Ignition Issues (F09) with AdvantagePlus

Rheem has received reports of customers experiencing difficulty in getting proper ignition on AdvantagePlus units out of the box. This issue is often accompanied by an F09 fault showing on the controls. See below for troubleshooting.

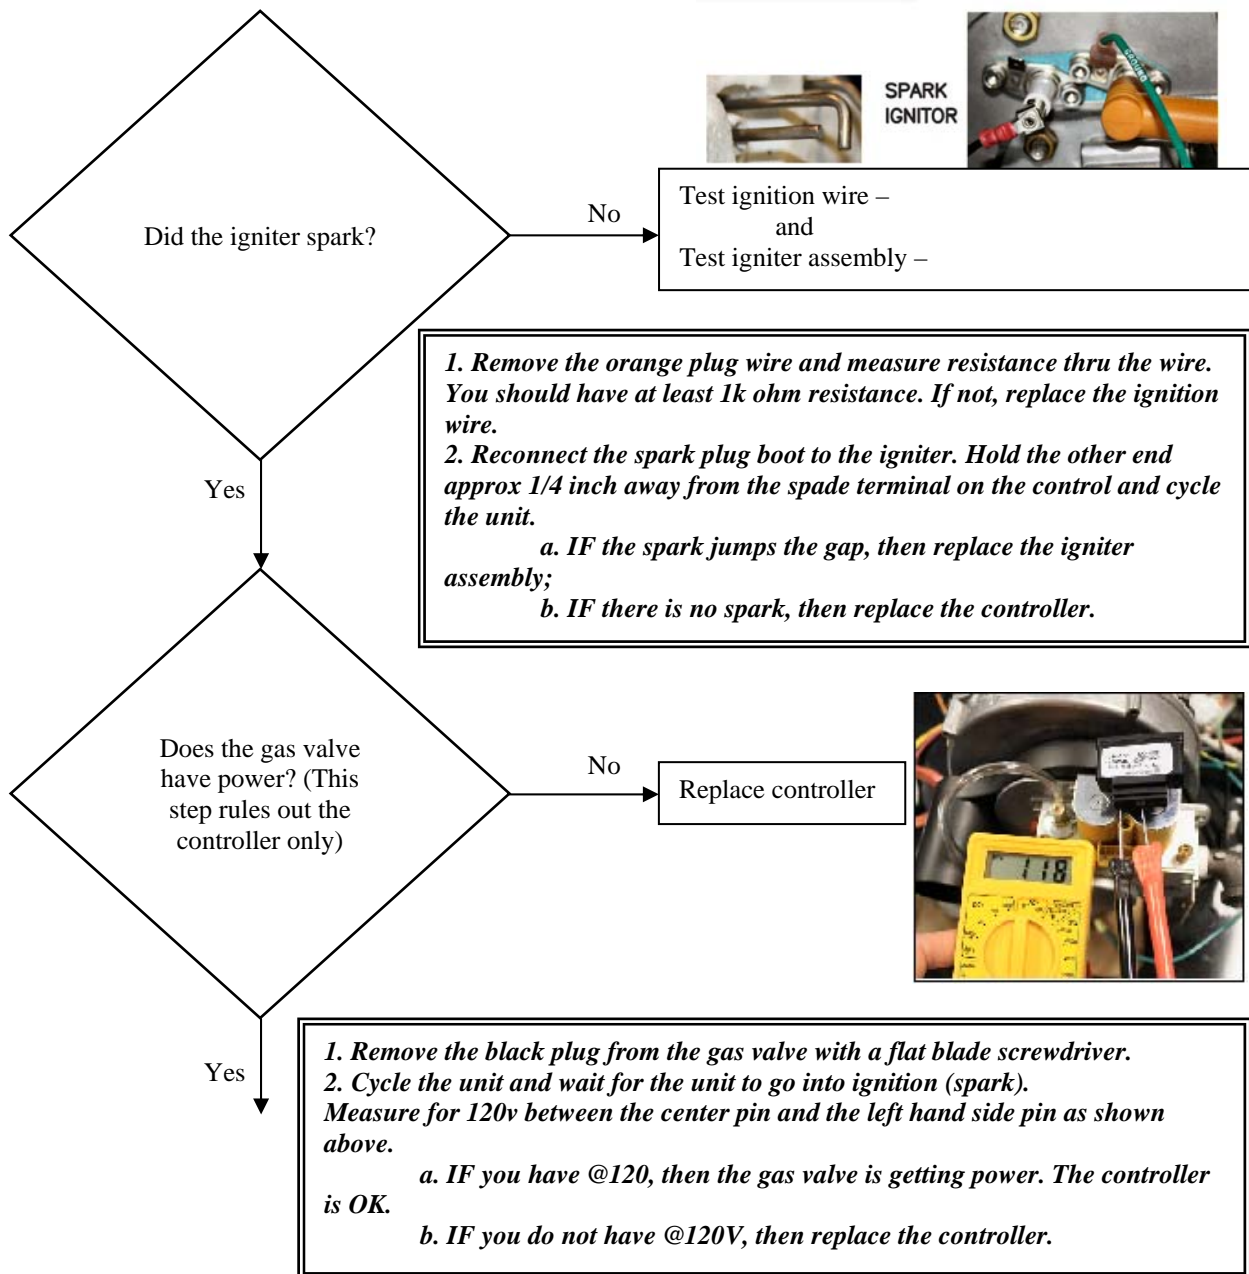
The igniter that is present in the unit as it ships is a natural gas igniter. We have found that replacing with the LP Conversion Kit igniter will often address the issue. The replacement parts are contained in a special conversion kit sent with each water heater.

Natural Gas Igniter

LP Igniter

Rheem recommends that if you replace the igniter that you properly re-set combustion as defined in the use and care manual.
